GFELLER LINE CONCENTRATOR
POWER SUPPLY PEC-8001-A
DC OPERATION

1.01 This appendix is issued to include the necessary information on units converted to DC battery operation.

SECTION 067-201-501PT
APPENDIX 1

Fig. 1A
Rectifier Schematic

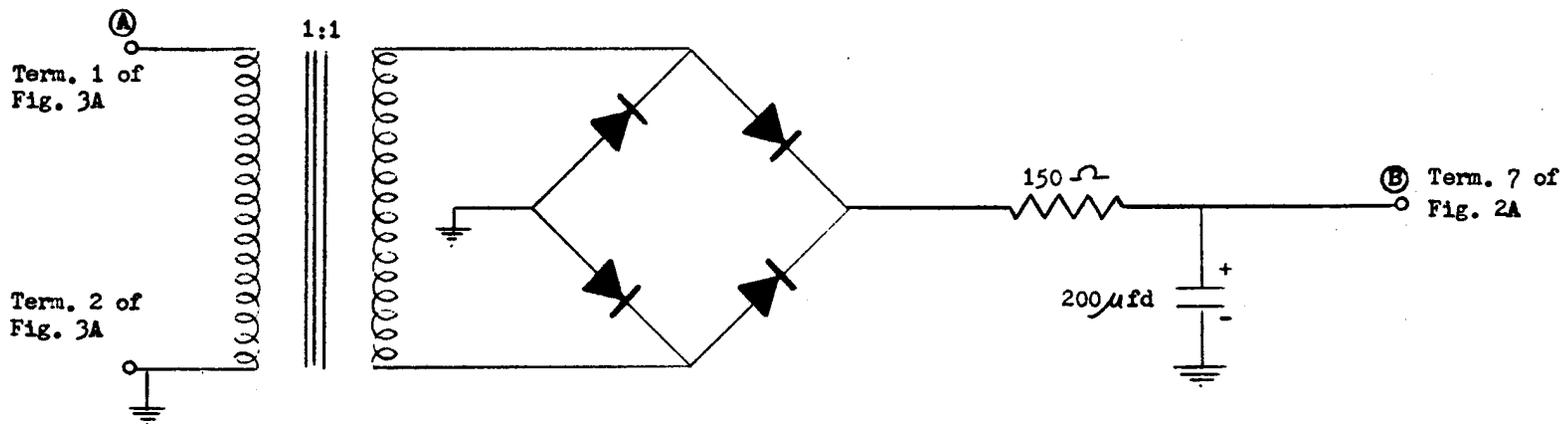
1.04 In order to function properly the modified Gfeller line concentrator requires power at a positive 45-50 volts dc in addition to -72 volts dc and/or -48 volts dc. A special rectifier, or positive dc power applique, (see Fig. 1A) is used to convert the 70-80 volt ac output of the PEC supplies to +45 volts dc for use by the concentrator unit. One rectifier unit is required for each concentrator.

Fig. 3A
700A Terminal Strip on Rectifier

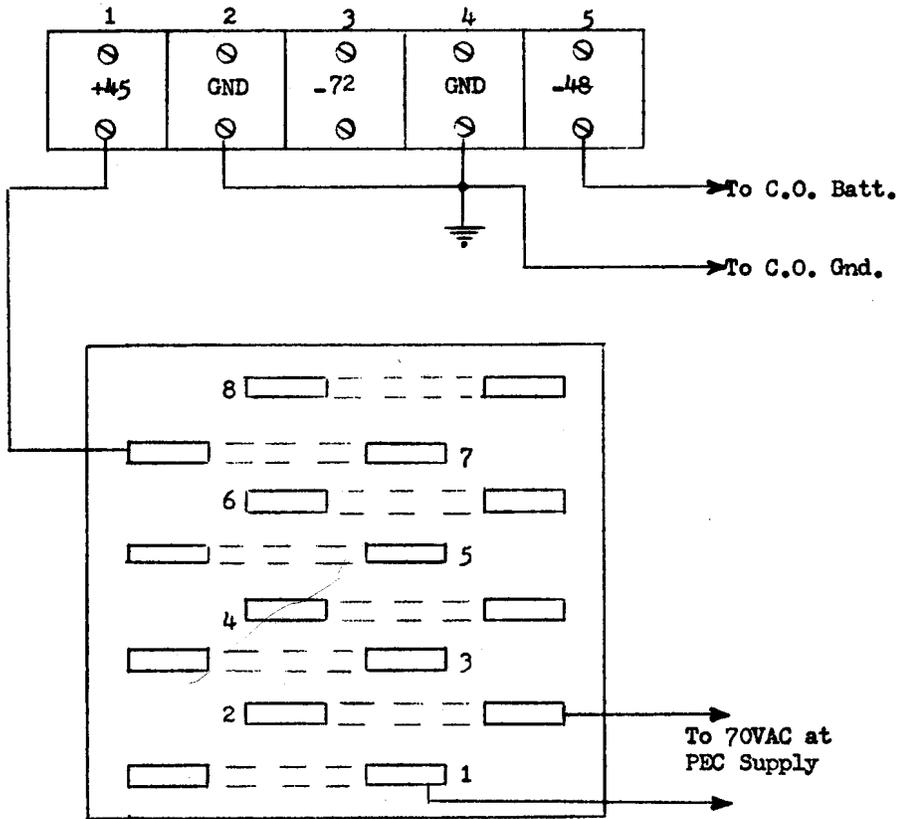
70 volts ac connects to the bottom two terminals of the 700A terminal strip (indicated by 1 and 2 in Fig. 3A) of the rectifier.

The next to the top terminal (indicated by 7 in Fig. 3A) of the 700A terminal strip of the rectifier connects to the +45 terminal of the power block (indicated by 1 in Fig. 2A).

70 volts ac connects to the bottom two terminals of the 700A terminal strip (indicated by 1 and 2 in Fig. 3A) of the rectifier.

The next to the top terminal (indicated by 7 in Fig. 3A) of the 700A terminal strip of the rectifier connects to the +45 terminal of the power block (indicated by 1 in Fig. 2A).
